Accessibility Survey

City of Downey Golden Street - Castana Avenue To End

Date of Inspection
11/30/2016

Disability Access Consultants

Curb Southwest Corner Of Dempster Avenue @ 33.909599090317, - 118.149463087320

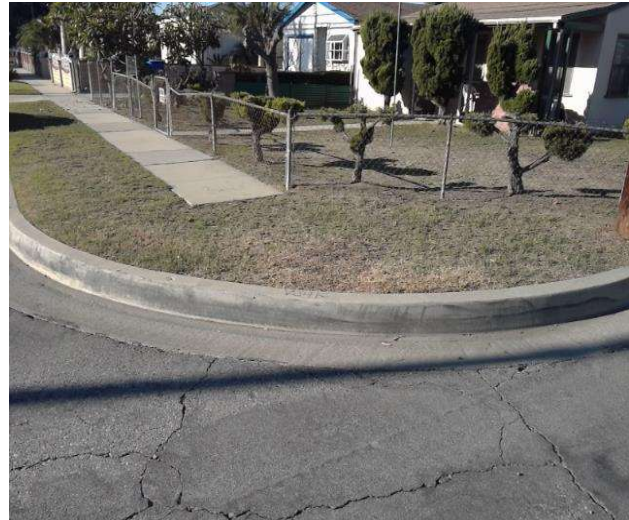
There is a curb on the designated path of travel.

On-Site Finding Not Compliant

Provide a compliant curb ramp.

Code Reference ADA 402, 303, 406, 403.4, 303.4

Sidewalk West Of Dempster Avenue @ 33.909599090317, -118.149463087320

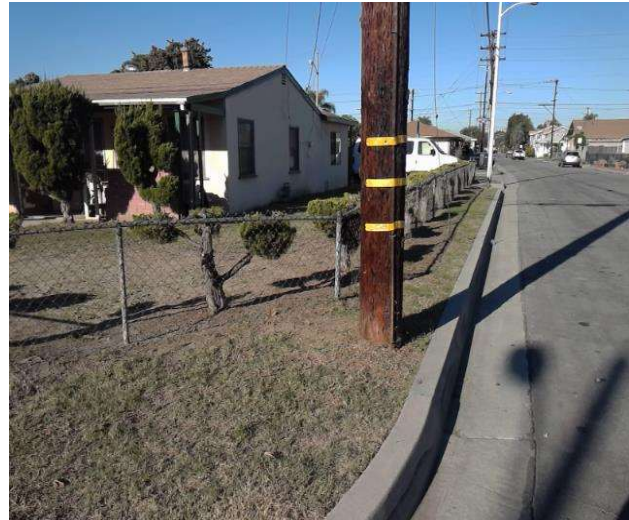
Section of sidewalk is missing and consists of dirt, grass or gravel.

On-Site Finding 100.00 feet

Provide a compliant sidewalk for the missing section.

Code Reference ADA 206, 302,CA 11B-302,CA 11B-206

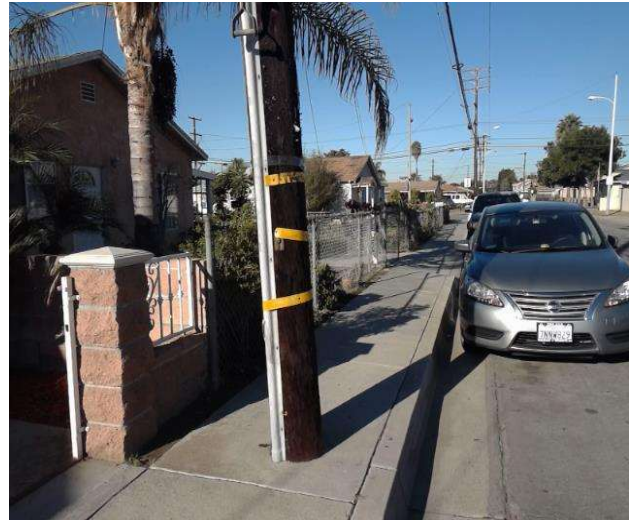
Sidewalk width at the obstruction is not compliant.

On-Site Finding 23.00 inches

Sidewalk width at the obstruction shall have the recommended value.
